Esperanza Hills Project

2018 Additional Environmental Analysis

Project No. PA120037
August 2018

Attachment B
Revised Maps Depicting Location of Chino Hills State Park

Exhibit 4-11
Planning Areas

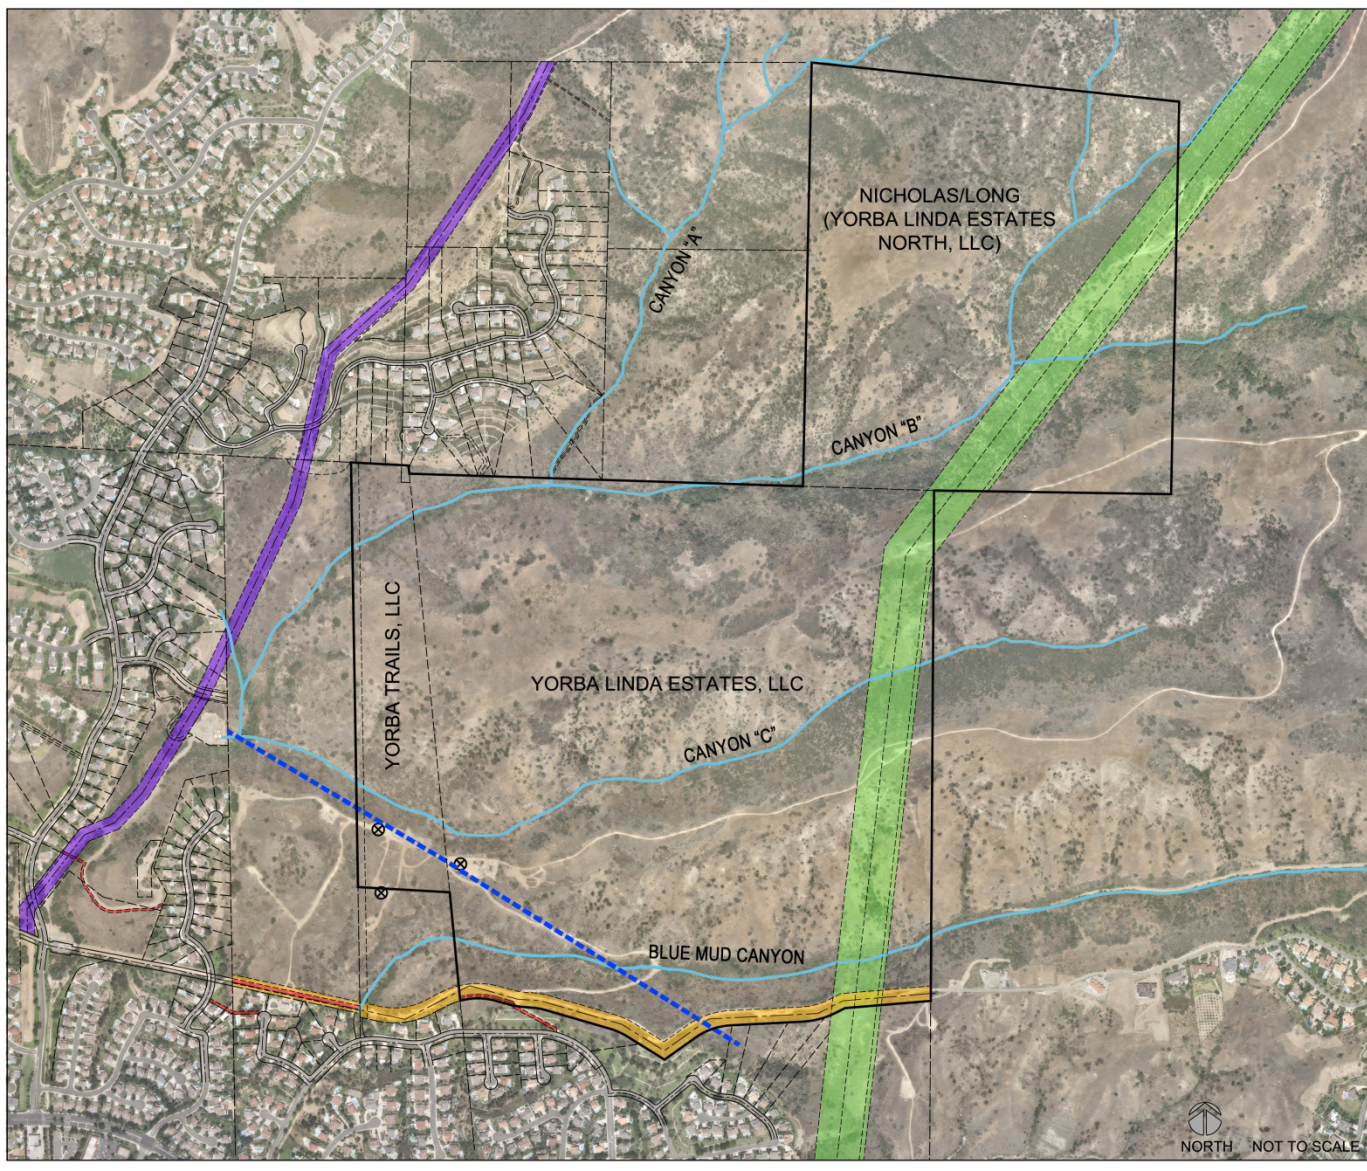
Exhibit 4-11 – Planning Areas, in Chapter 4, Section 4.3, was updated by removing the incorrect property line that showed CHSP only to the east of the Nicholas/Long property.

Exhibit 5-1
Scenic Highway Plan

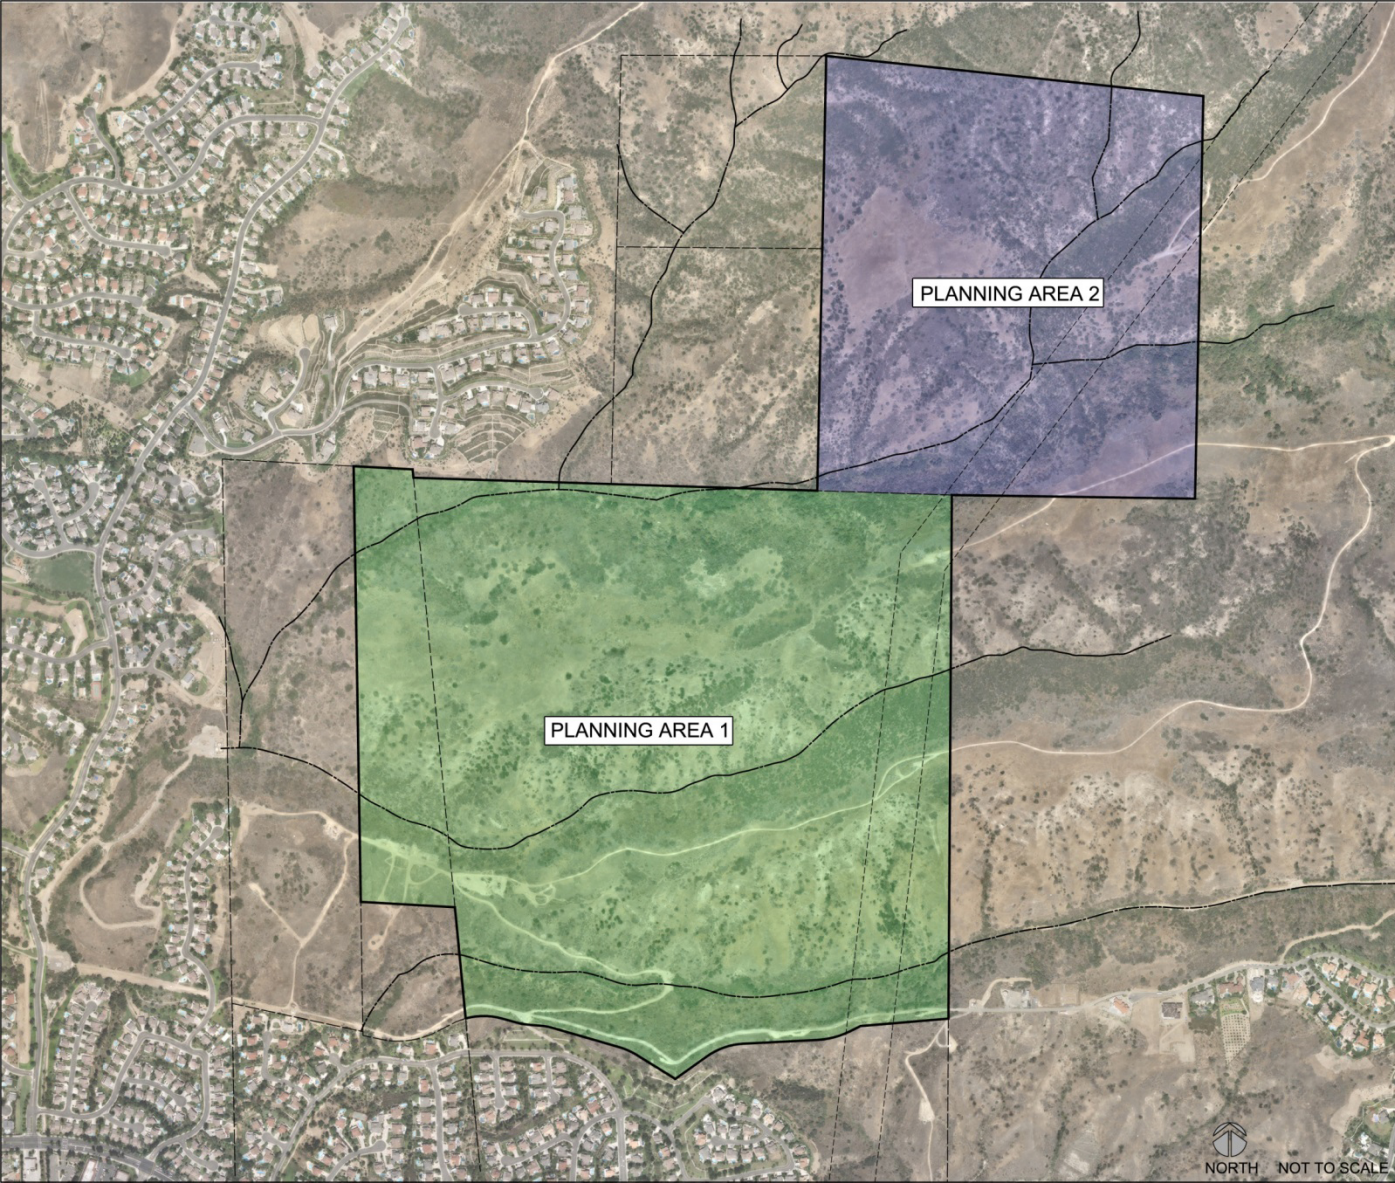
Exhibit 5-1 – Scenic Highway Plan, County of Orange, in Chapter 5, Section 5.1, was updated to reflect the current property boundaries for CHSP.

**Evacuation Plan, Orange County Sheriff's Department/City of
Yorba Linda**

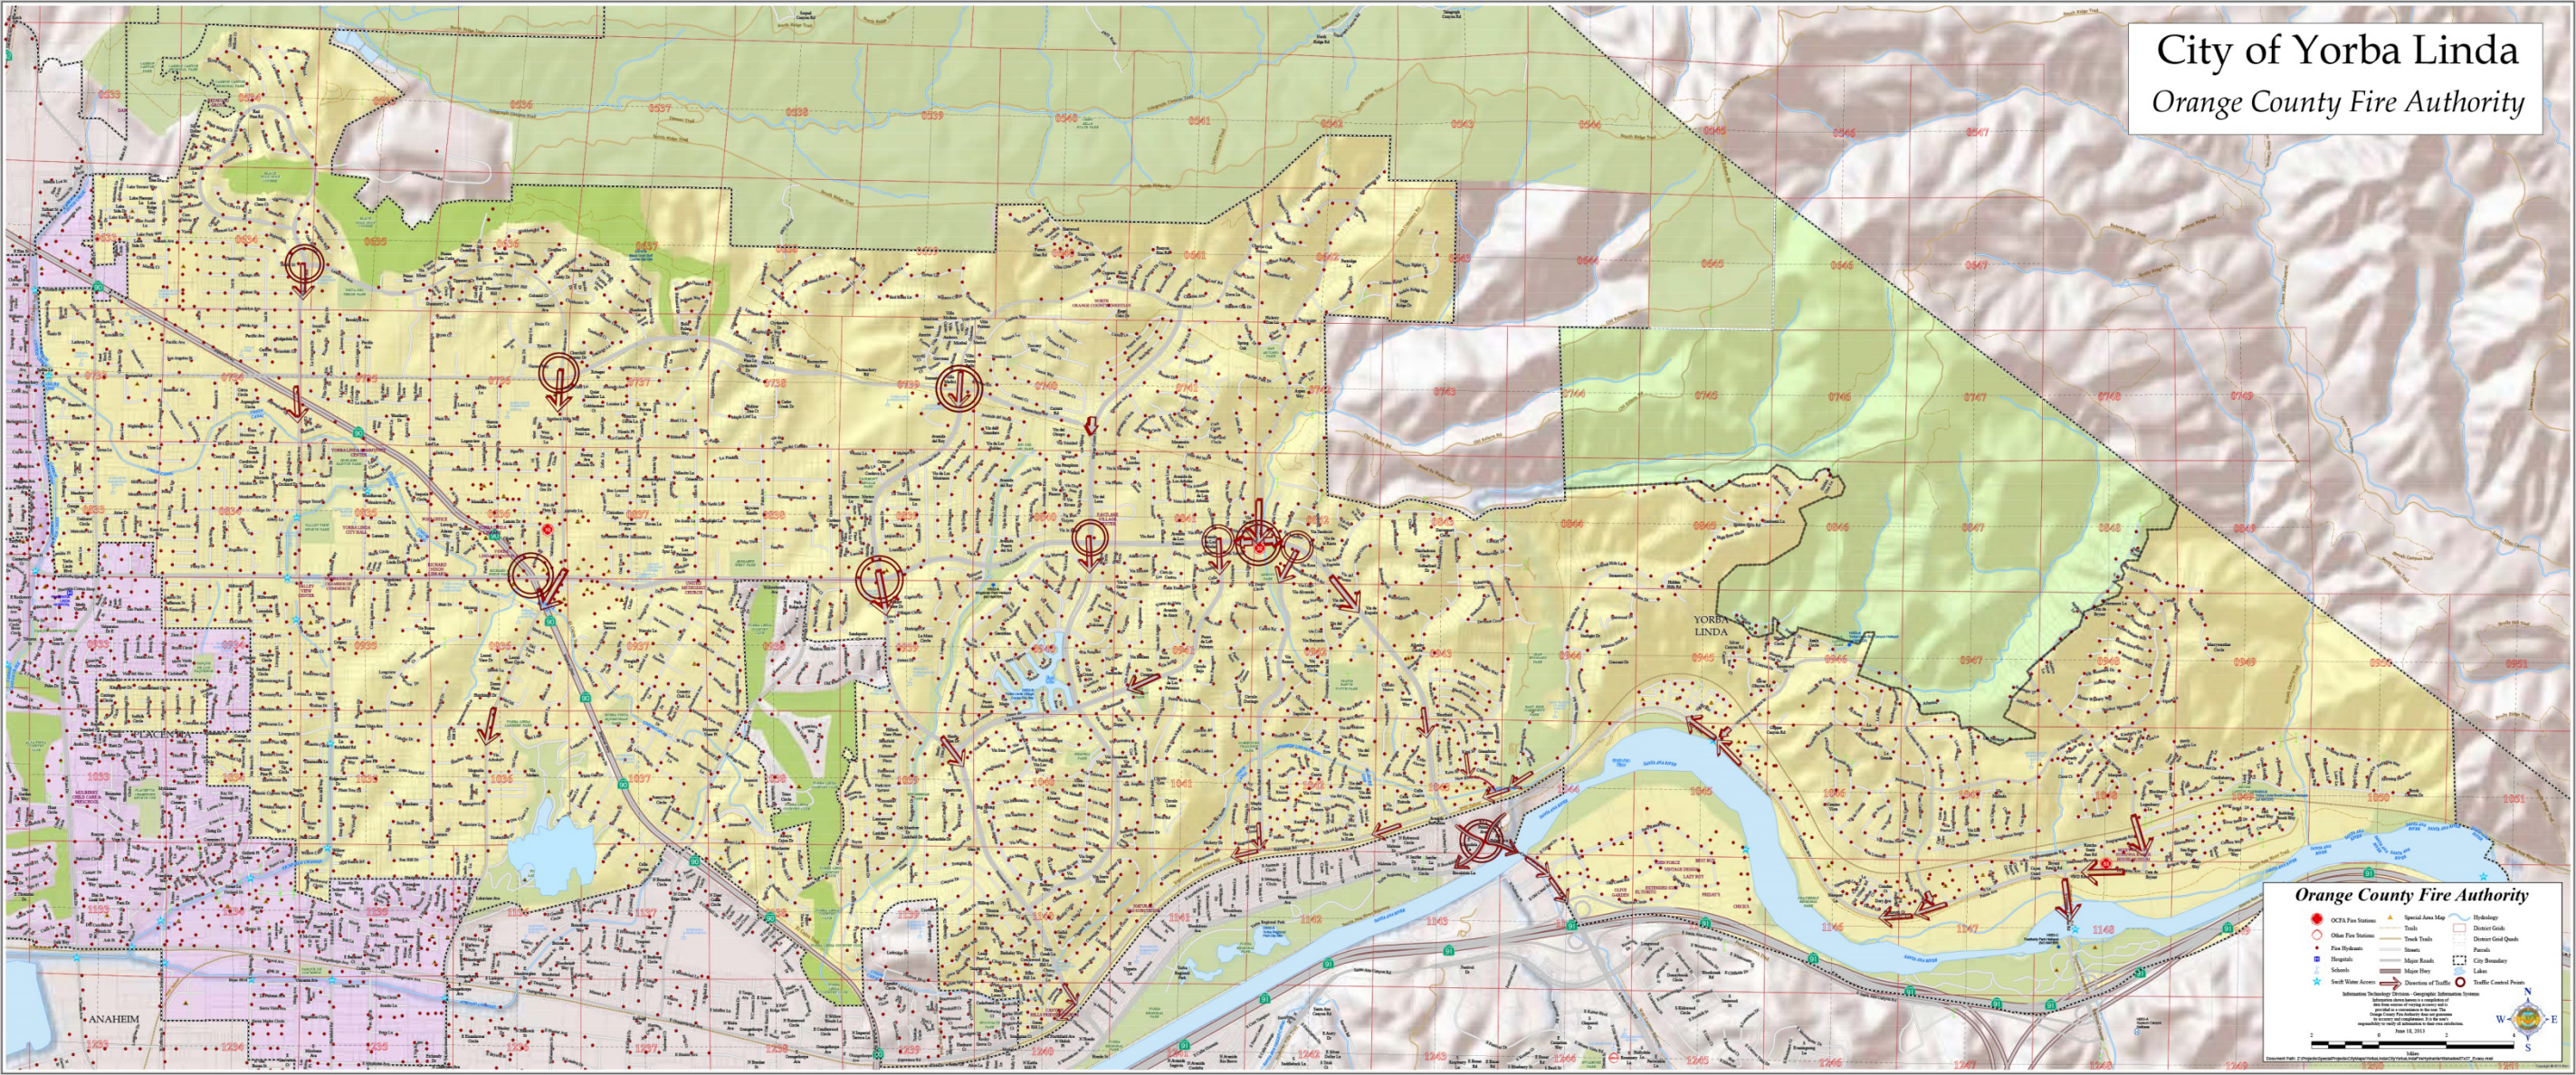
Exhibit 5-68 – Evacuation Plan, Orange County Sheriff's Department/City of Yorba Linda, in Chapter 5, Section 5.7, was updated the CHSP boundary to east of Project.

Exhibit 5-84

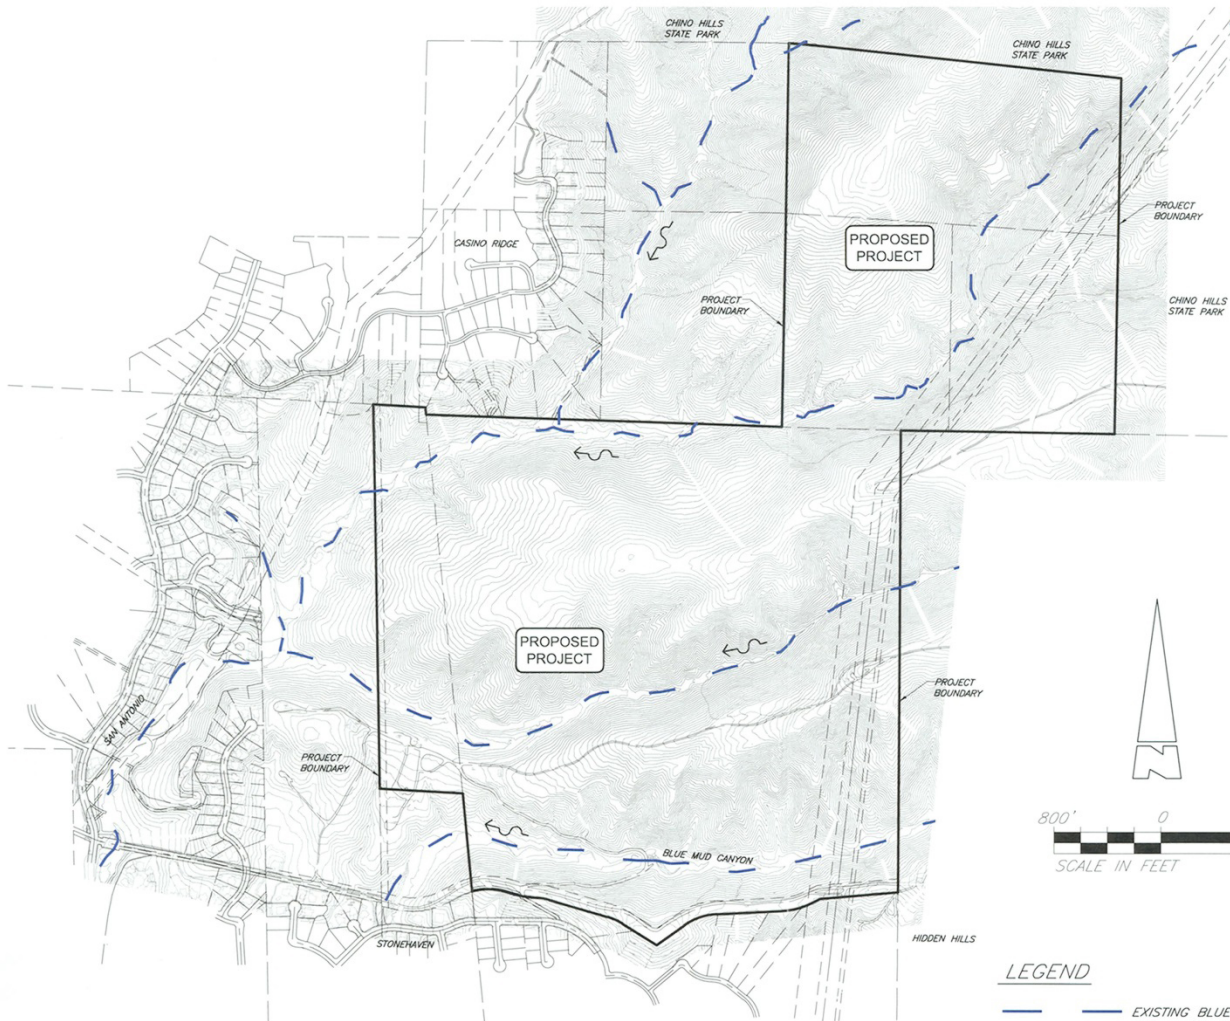
Exhibit 5-84 – Esperanza Hills Existing Topography and Drainage Areas, in Chapter 5, Section 5.8, vicinity map portion of the exhibit was updated to show the correct boundaries of CHSP.

**Esperanza Hills CWQMP Best Management Practices – Option 2,
Aspen Way**

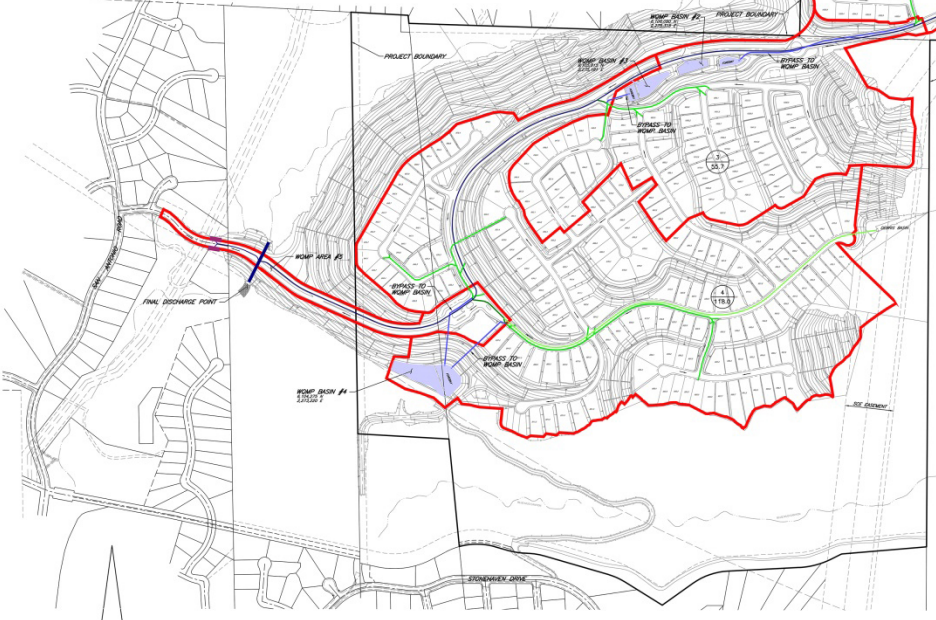
Exhibit 5-92 – Esperanza Hills CWQMP Best Management Practices – Option 2, Aspen Way, in Chapter 5, Section 5.8, was updated to reflect the correct boundaries of CHSP in the vicinity map portion of the exhibit.

Exhibit 5-97

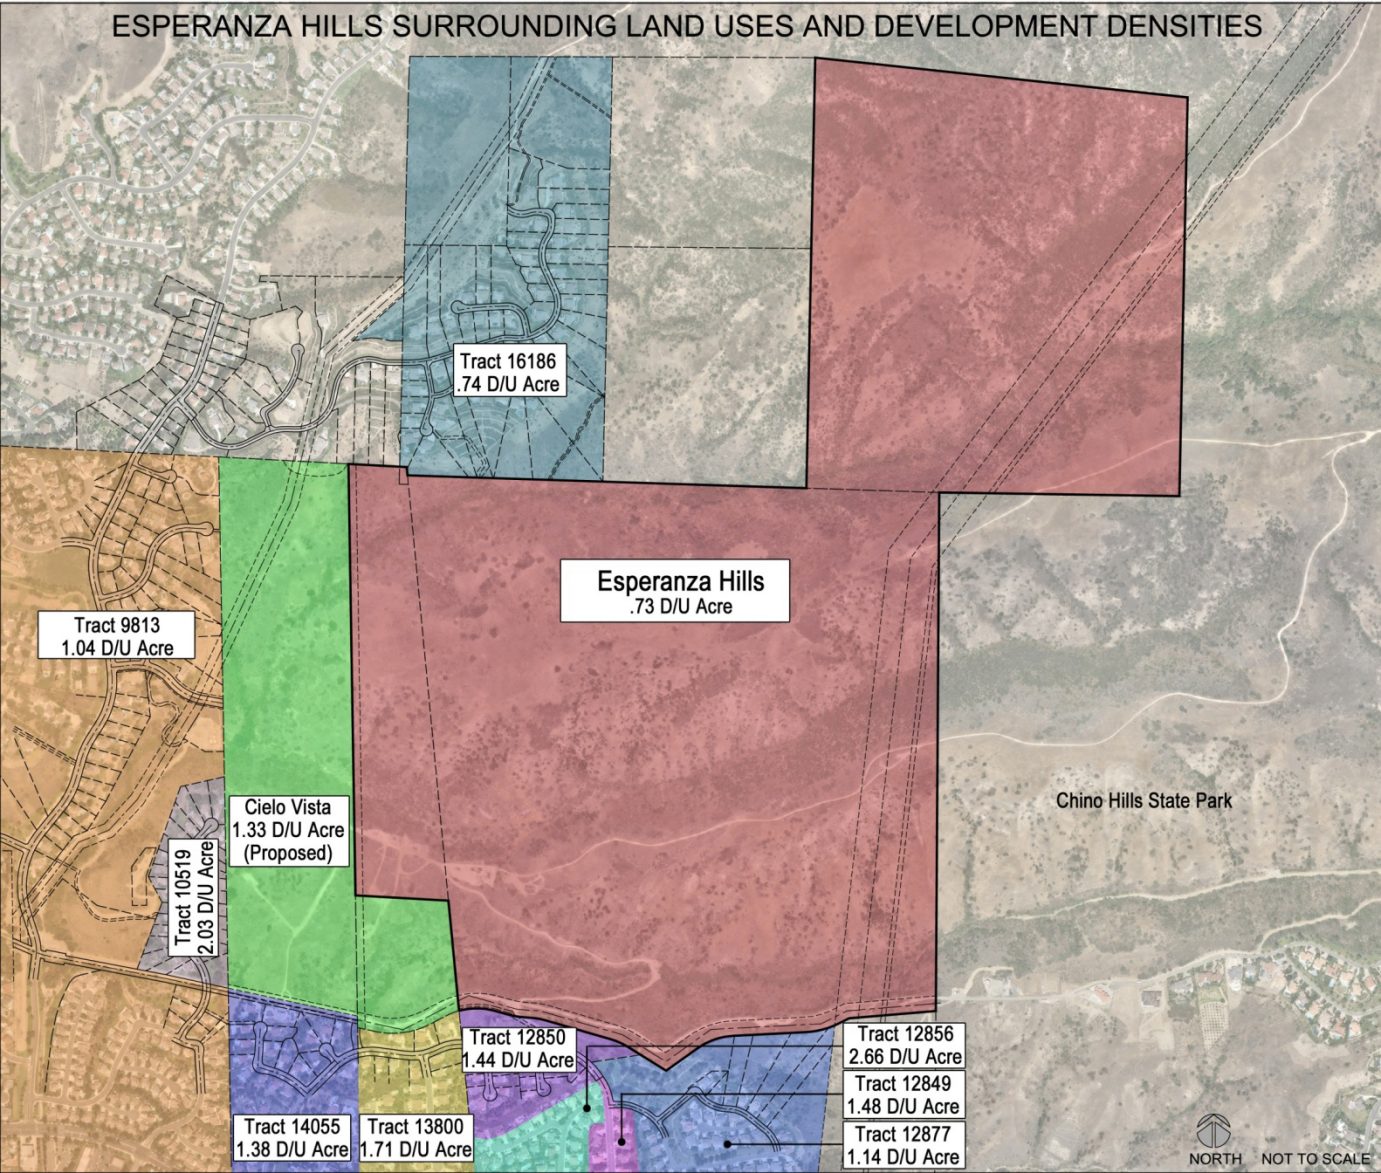
Thanks for taking my call and showing me that figure 5-97 needs to be changed. We will get on that and get it fixed and submitted this week. That map came from the City, I believe, before it transferred the land to the park. To be clear, we have always contended that all of the land directly east of us is part of the park, and that is what was analyzed in the DEIR.
